RE: White Lake Retail Building-9197 Highland Road - Preliminary Site Plan Review- 2nd Review

DLZ # 2645-8022-04

**Amended Site Plan / Planned Business Review
for
White Lake Charter Township, Michigan**

Applicant:	Ronald Chiesa
Project Name:	59 & Fisk Holdings/ 9197 Highland Rd
Plan Date:	February 26, 2026
First Revision	May 4, 2026
Second Revision	July 9, 2026
Location:	South of Highland Road, at the southern point of Fisk Road. Parcel ID: 12-23-227-008
Action Requested:	Amended Site Plan / Planned Business Approval

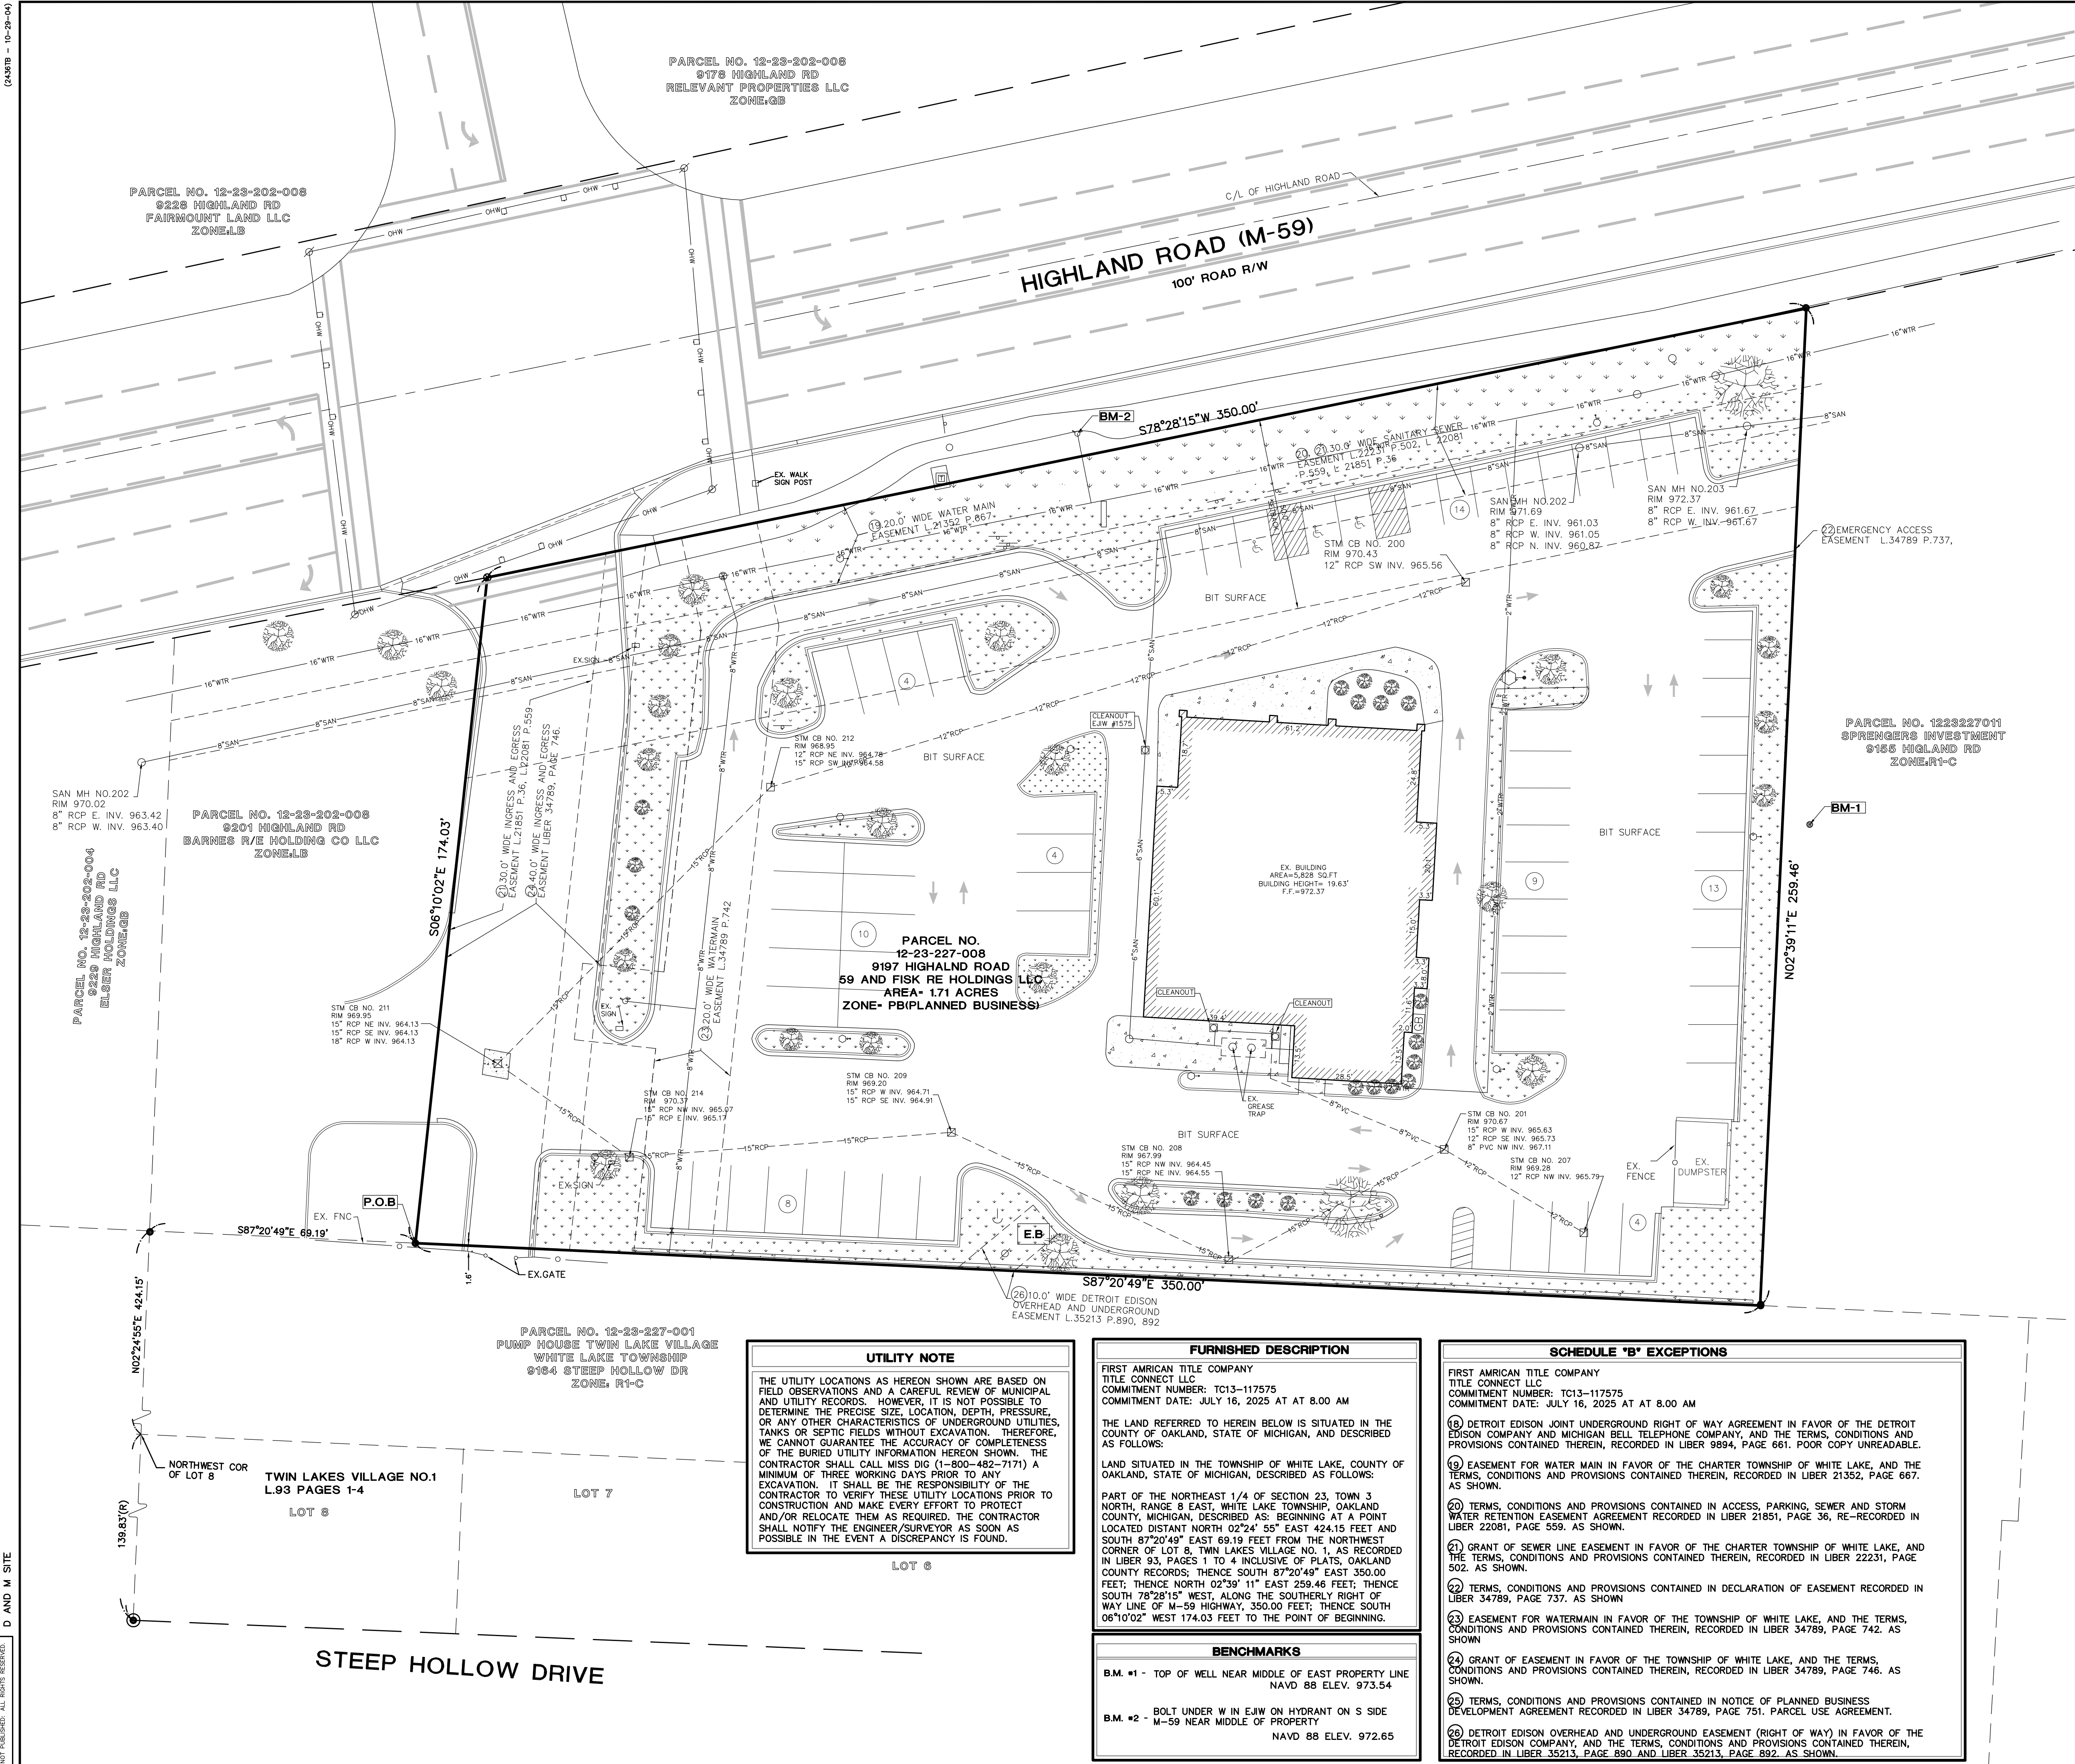
- The plan violates the max footcandle limit of 0.2 at residentially zoned lot lines to the south. This property do not appear to be used as residential.
- The existing parking lot perimeter light poles appear to violate the max height allowance of 16 feet when within 25 feet of a lot line.
- The site's general average footcandle is 1.5 fc. The standard states the average footcandle measurement should be .5 fc.

- 1) *The site's general average footcandle measurement exceeds the .5 fc standard. Planning Commission will need to determine if this is acceptable.*
- 2) *Footcandle measurements at residential lot lines and existing light pole height do not meet current standards. If proposed to remain, the Planning Commission will need to consider a waiver.*

10. Site footcandle averages should be added to the plan per Section 5.18.G.viii.
Our plan Sheet AS-3 shows the Photometric Plan.
11. Footcandle measurements at residential lot lines and existing pole height do not meet.....
The existing site pole lights, location and heights are to remain unchanged. The two new light poles we are providing east of the New Canopy shall meet the ordinance and be 20' high. We do meet the requirements for fc levels per the ordinance at adjacent property lines. See AS-3.
